COVER SHEET & GENERAL INFORMATION

Enclosed, please find the updated civil plans and landscape plans along with the accompanying response letter for the Siberian Elm Subdivision (previously 43rd Street Townhomes), located at 216 E. 43rd Street. Additional attachments, such as the revised and signed Preliminary Plat, Final Plat, have been included with this re-submittal for your review. The response letter, dated June 22nd, 2026, provides a comprehensive, itemized response to each of the review comments received for the cursory review. Each comment was carefully evaluated and addressed in detail to ensure that all concerns were resolved in a clear and satisfactory manner. Below are the following items addressed from the cursory review:

LANDSCAPE PLAN

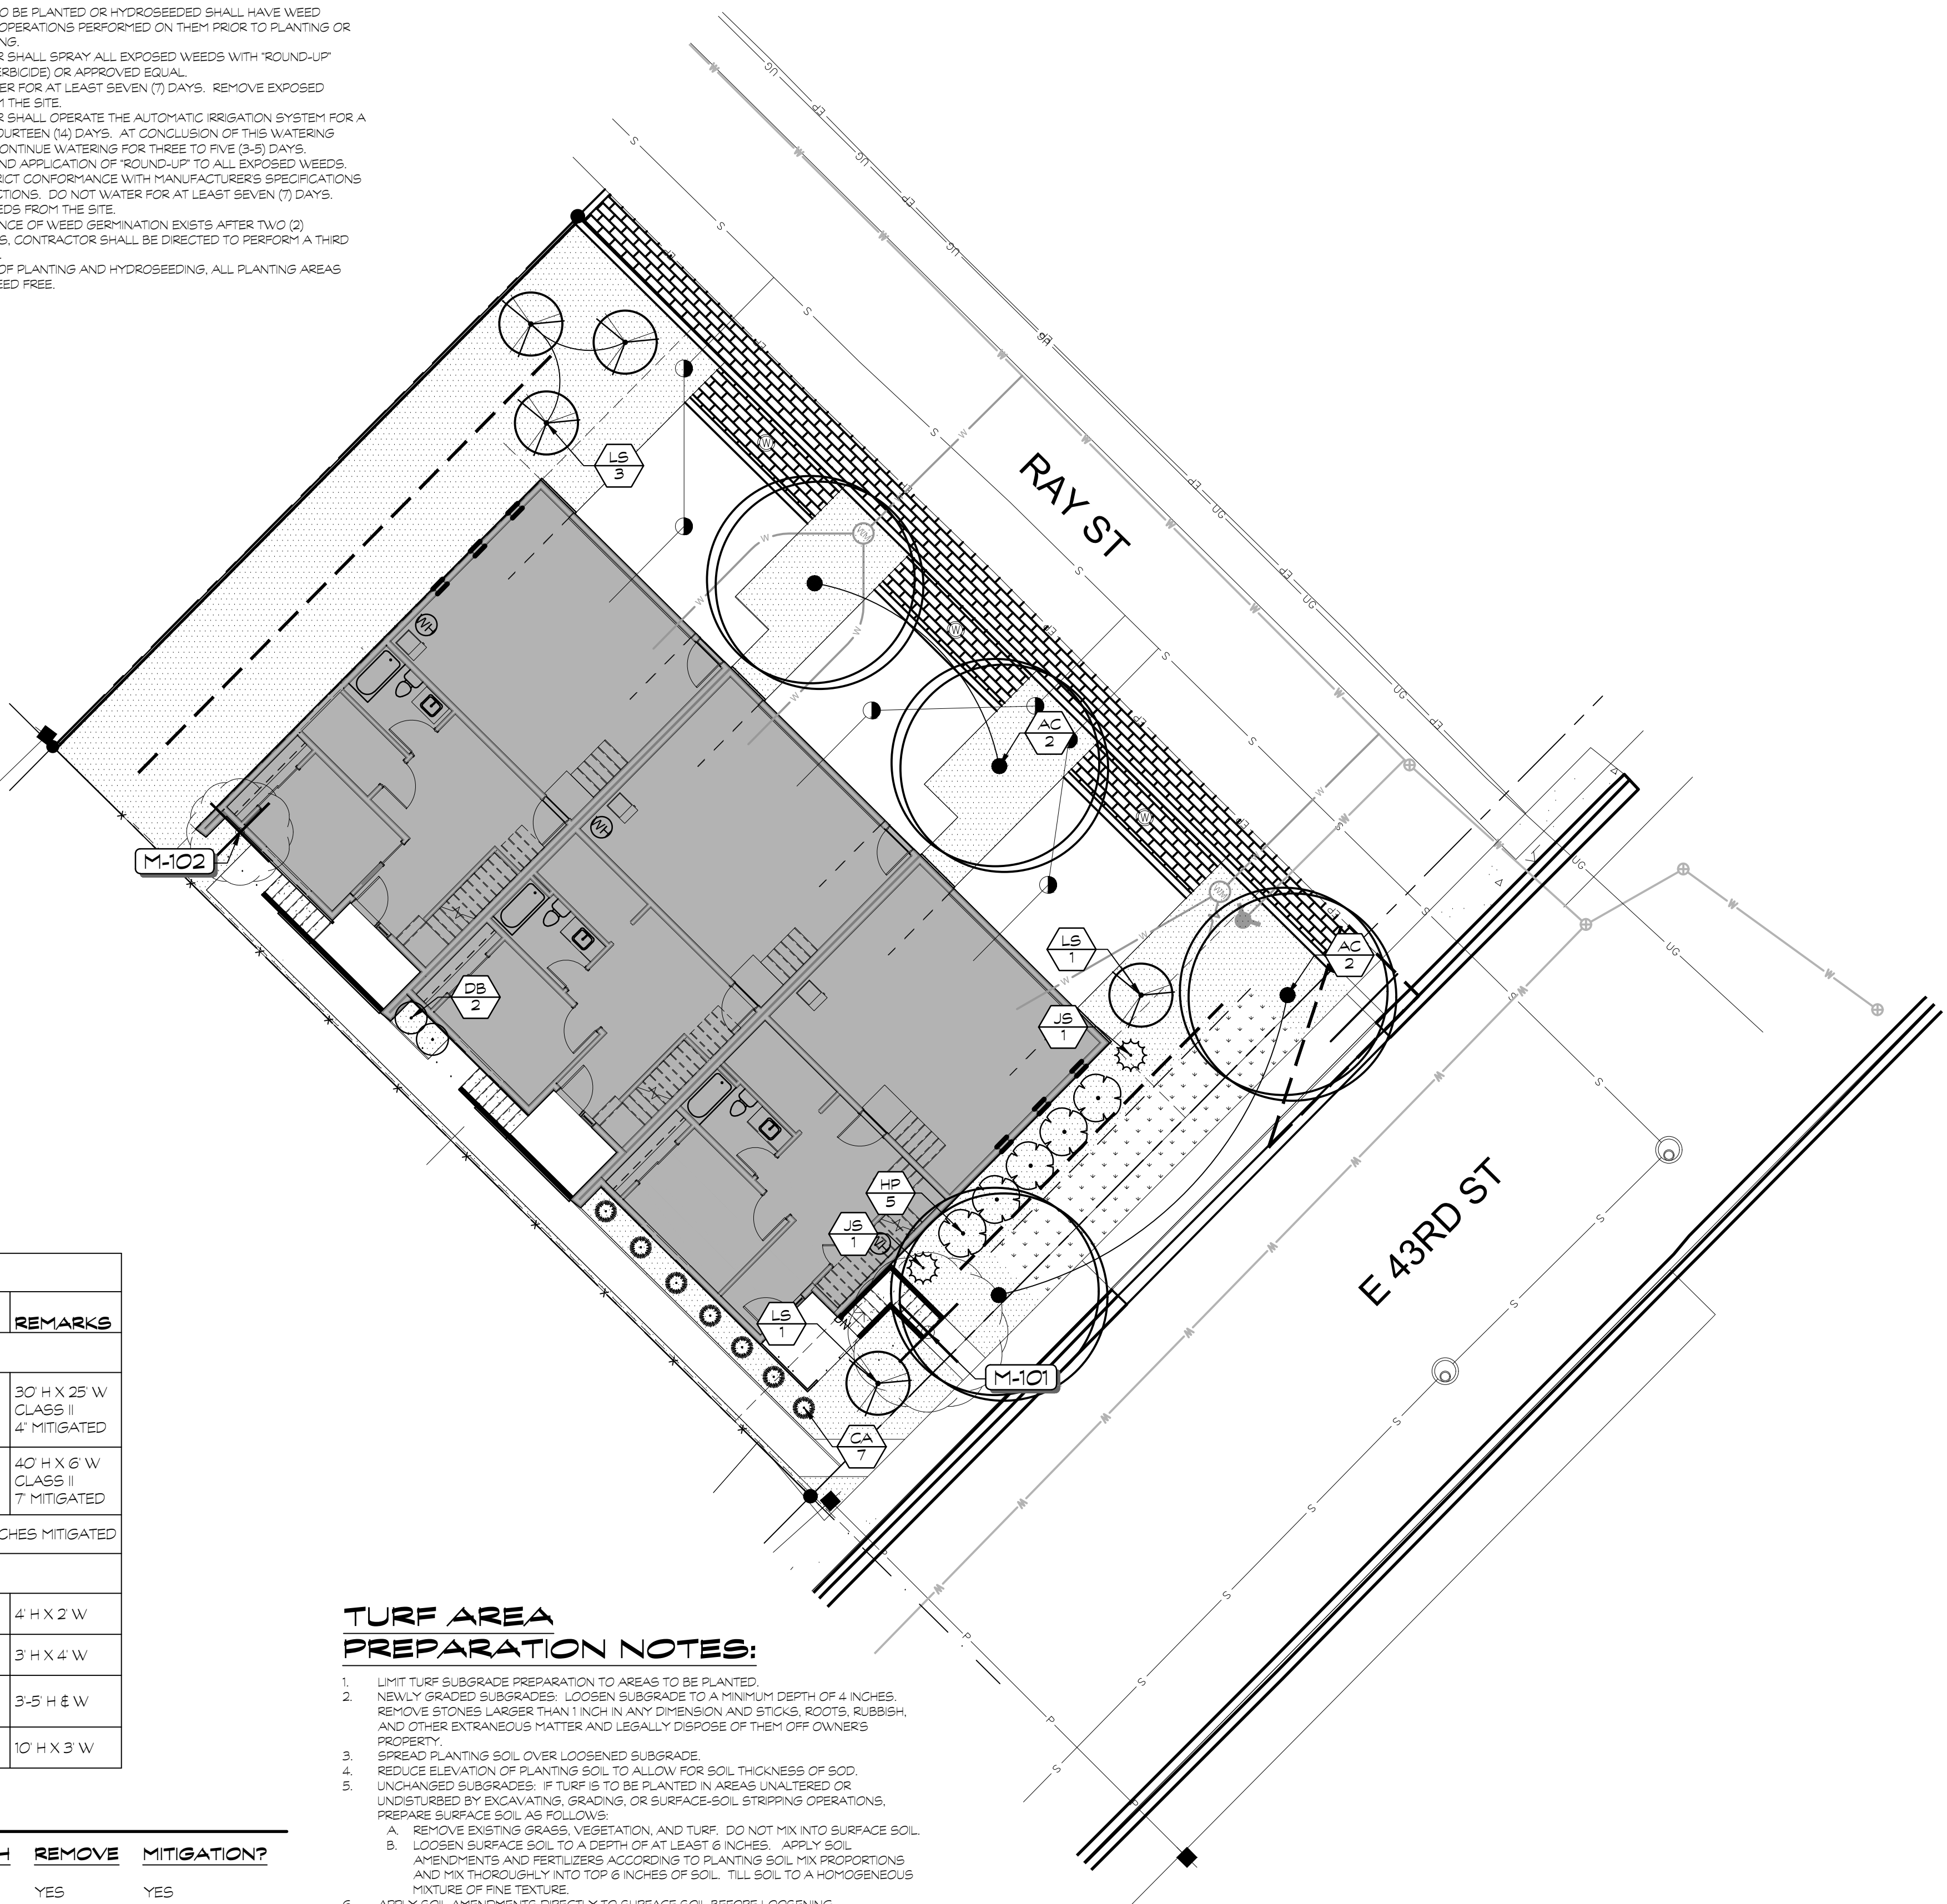
Landscape Plan: It seems the trees shown near Ray and 43rd Street may conflict with planned storm water improvements. This should be reviewed and resolved.
